RECEIPT DATE: 5/18/18 **ONSITE SEWAGE DISPOSAL SYSTEM**

PROPERTY ADDRESS: 1041 Fairlane Road

SUBDIVISION: Fairlane Farms

The OSDS Plan for 1041 Fairlane Road has been reviewed with the following comments:

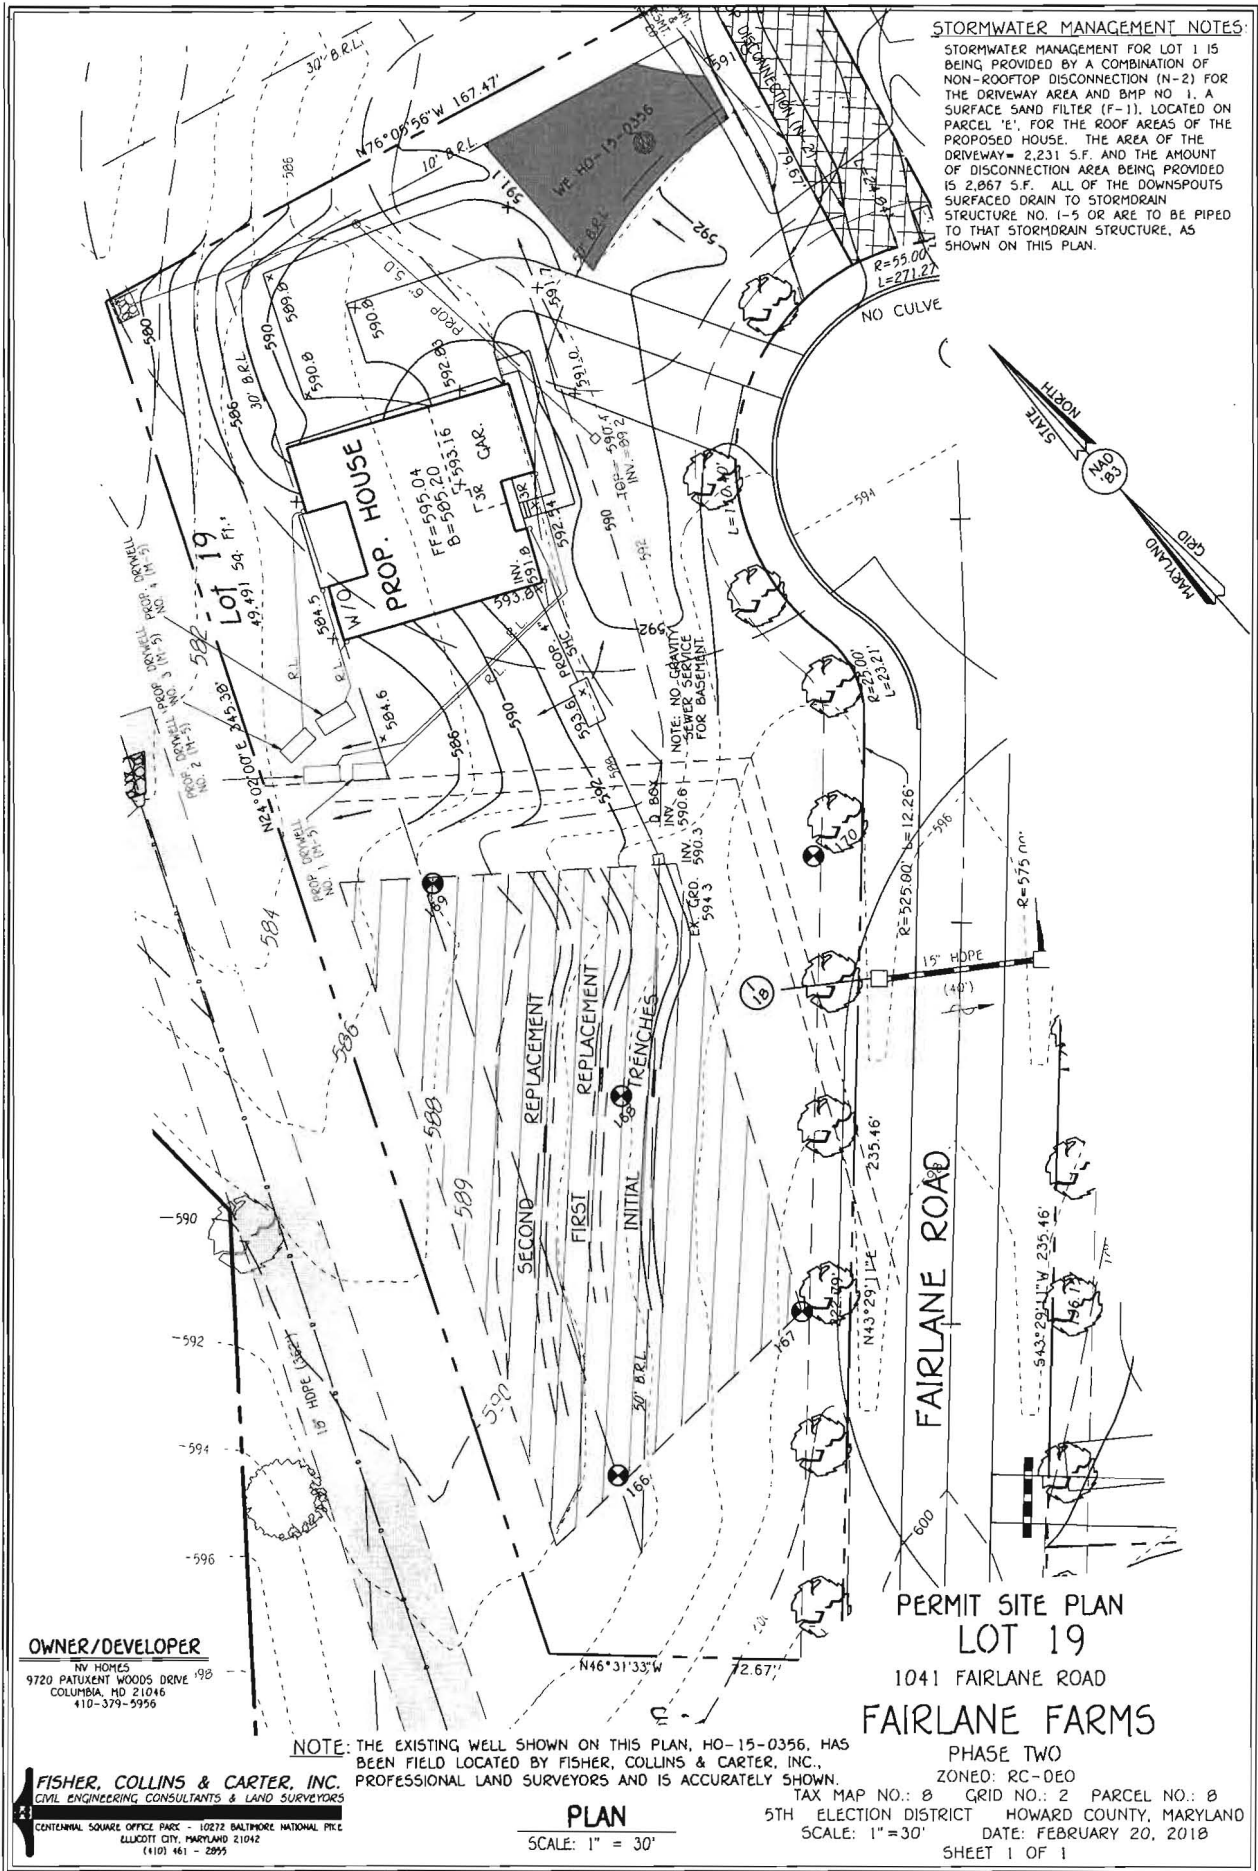
Tony had sent you a preliminary siting on this lot and ran by the trench layout that had the initial septic trenches situated over 20 ft. lower in the septic area because we thought that was going to be necessary to enable this house to have gravity sewer service for the first floor. You had showed that to Jeff Williams and he didn't like not utilizing more of the upper portion of the septic area, despite 3 systems easily fitting within the approved septic area. However I have finalized the siting and revised the trench layout (see the attached), showing the initial septic trench starting about 22 ft. further up the septic area (at the top of the closest corner to the house of the approved septic area. This enables a 4th system to easily fit below the 3 that have been laid out and is certainly in line with many of the other lots approved previously. Since you looked at this before with the layout of the septic trenches so low in the field, I just wanted to run this by you and make sure you agree, that this is a big improvement and works well. There is no sense in having a whole house pump system when it's not necessary. Not just for cost, but because of reliance on power and the potential for maintenance headaches for the homebuyer.

We are fine with this layout.

**PERMIT SITE PLAN
LOT 19
1041 FAIRLANE ROAD
FAIRLANE FARMS**

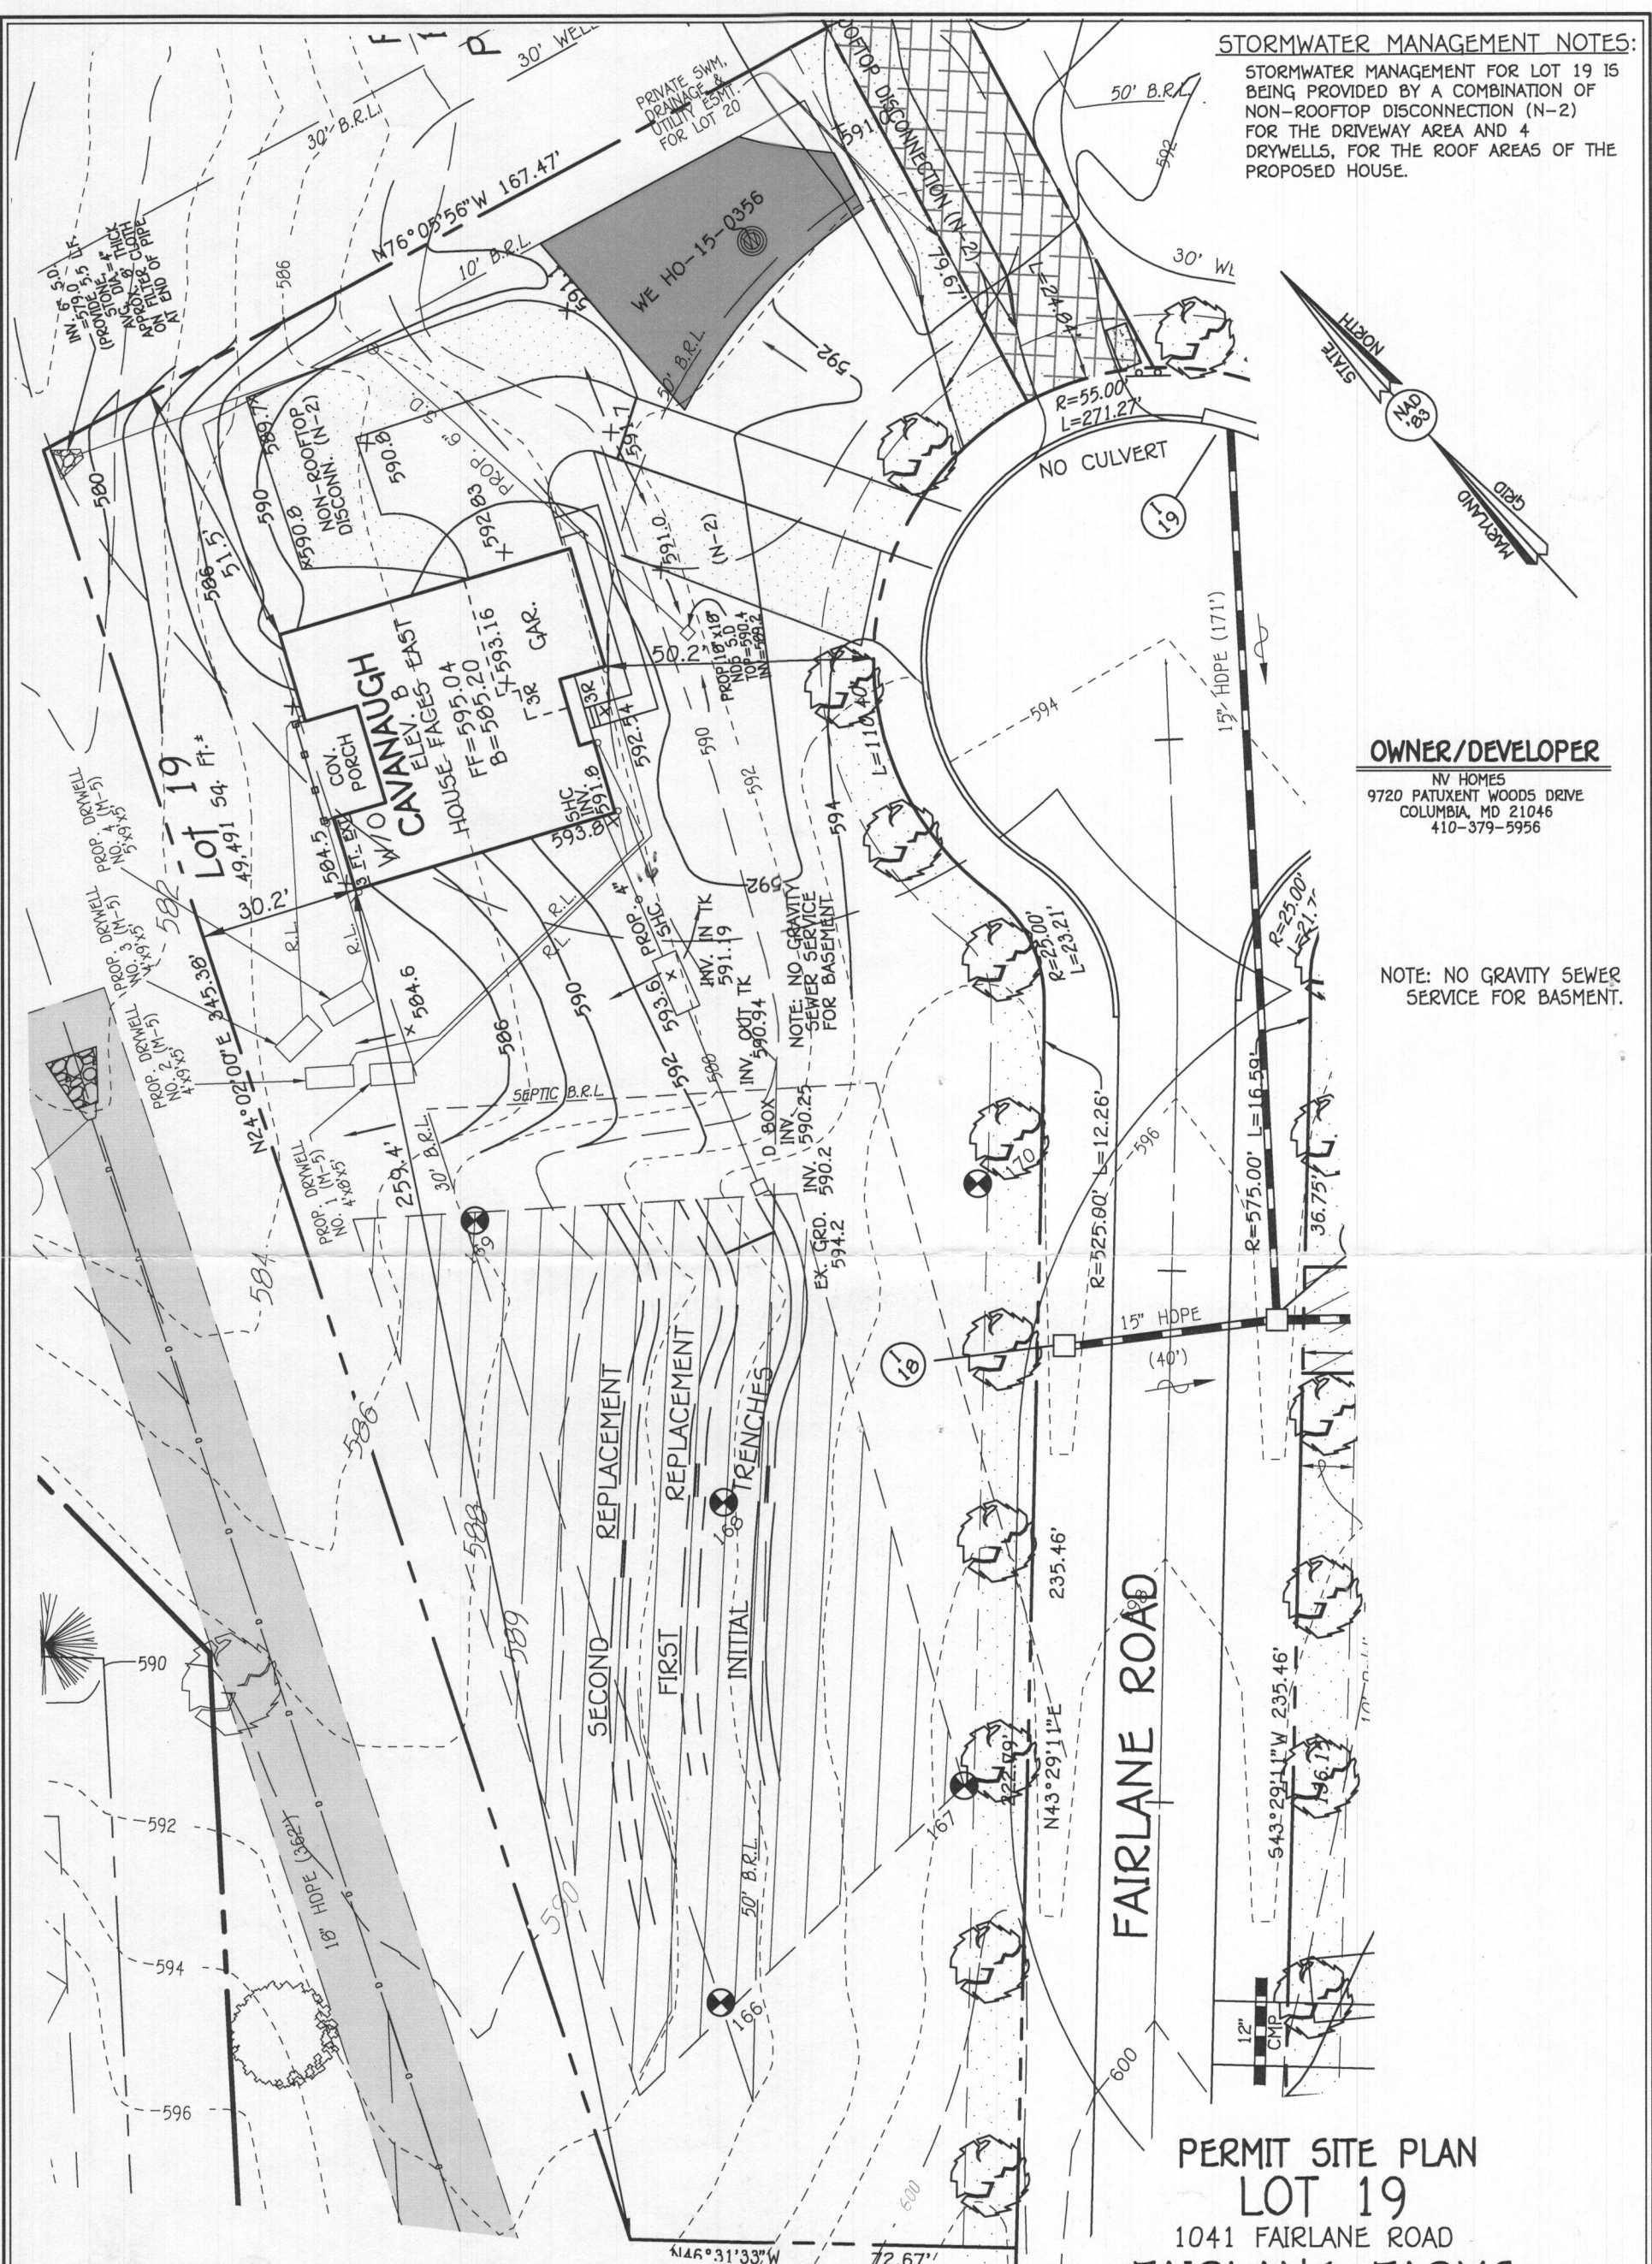
- 1.) Well box does not meet 10 foot setback to driveway.
- 2.) 18x 18 Storm water inlet grate does not meet 50 foot setback to well box.
- 3.) "Septic Profile" invert elevations out of house do not match (591.81 vs. 592.05).
- 4.) "Septic Profile" elevations do not match list of elevations next to trench detail.
- 5.) "Septic profile" length of pipe to first clean out (20 ft.) does not match length of pipe to clean out on plan layout (16 ft.).
